Architectural Review Board

Staff Report (ID # 10838)

Report Type:	Subcommittee Items	Meeting Date: 12/5/2019
Summary Title:	250 Sherman: Subcommittee Review of Public Safety Building Tower Design	
Title:	250 Sherman [17PLN-00256]: Subcommittee Review of a Previously Approved Project That was Conditioned to Return With Project Changes Related to the Tower Design for the Public Safety Building. Environmental Assessment: Certified Environmental Impact Report. Zone District: Public Facilities (PF). For More Information Contact Chief Planning Official Amy French at amy.french@cityofpaloalto.org.	
From:	Jonathan Lait

Figure 3. 80' PAPS B Monopole attached to new PSB at 55' above ground plane. Total height of building and monopole tower is 135'.

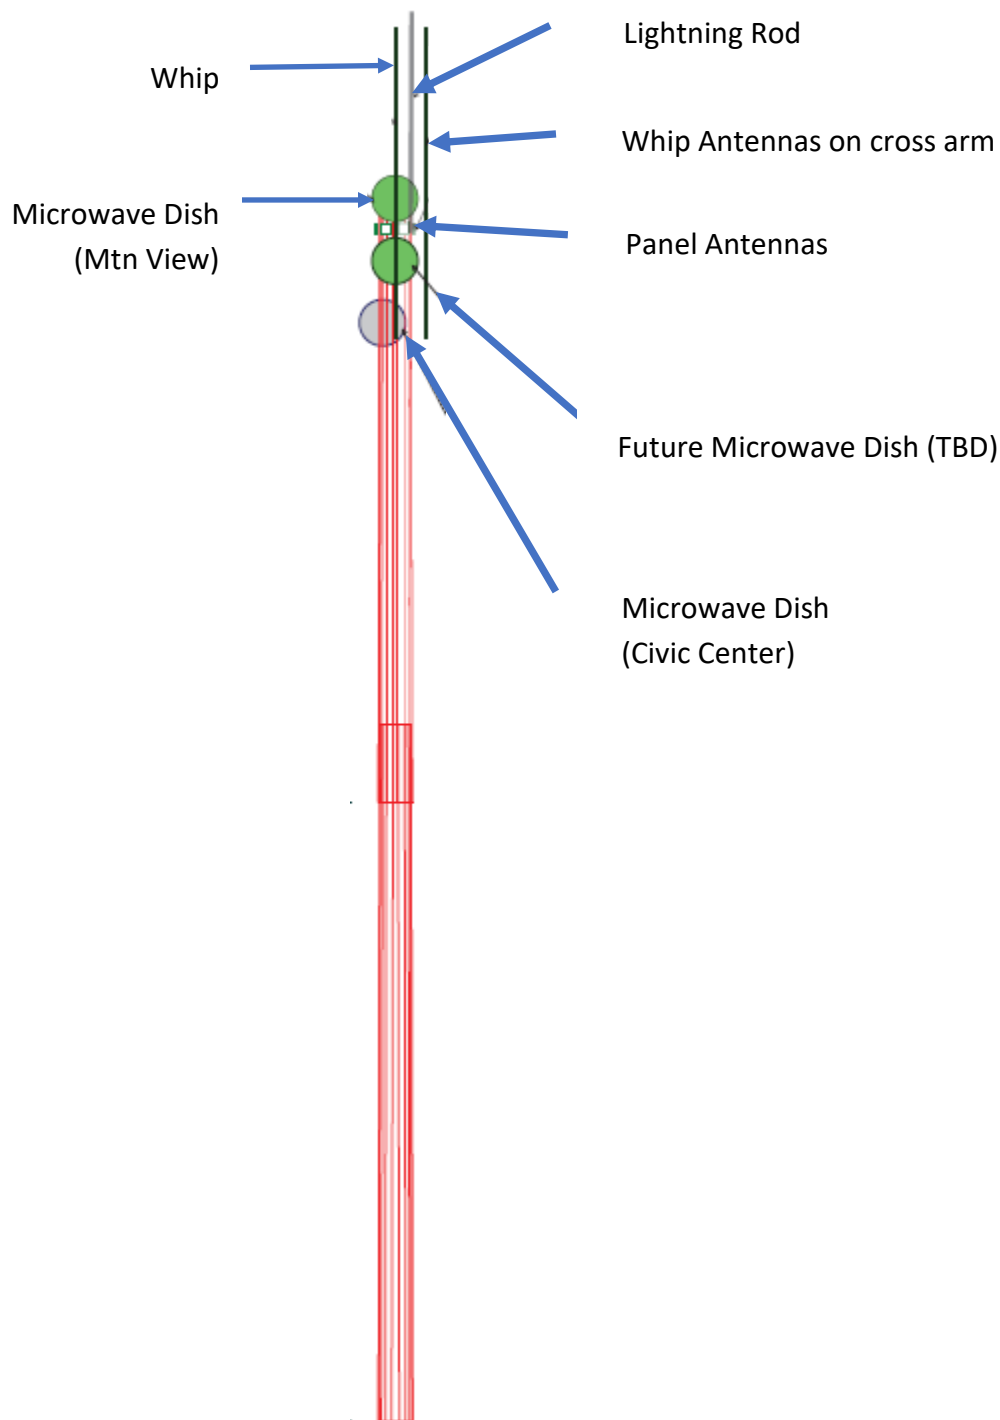
The communications tower's base is attached to a building mounted steel armature exterior to the building at 55' above ground, which results in the top of the monopole tower being at 135' (Figure 3) above the ground plane. This height is required to ensure the signal path of the microwave antennas are not attenuated to foliage, buildings, or other obstructions, and was determined by an engineering analysis.

Originally the building's monopole mounting armature was planned to be internal to the brick vertical tower chase on the building. Following additional study, it became apparent the amount of deflection estimated to be experienced from wind or seismic movements at the tower roof plane would be excessive and require a custom seismic expansion joint which would be problematic to design, waterproof and warranty. Consequently, the monopole mounting structure was shifted from the interior of the vertical brick tower to the exterior of the building similar to early images of the tower design presented to the City of Palo Alto. In so doing, the elevation of the brick tower structure facing Park Blvd was reduced in width by approximately 50% from that depicted in the prior ARB submittals. The overall brick tower height remains unchanged. The exterior surface mounted location avoids the expansion and deflection issues at the roof/monopole interface.
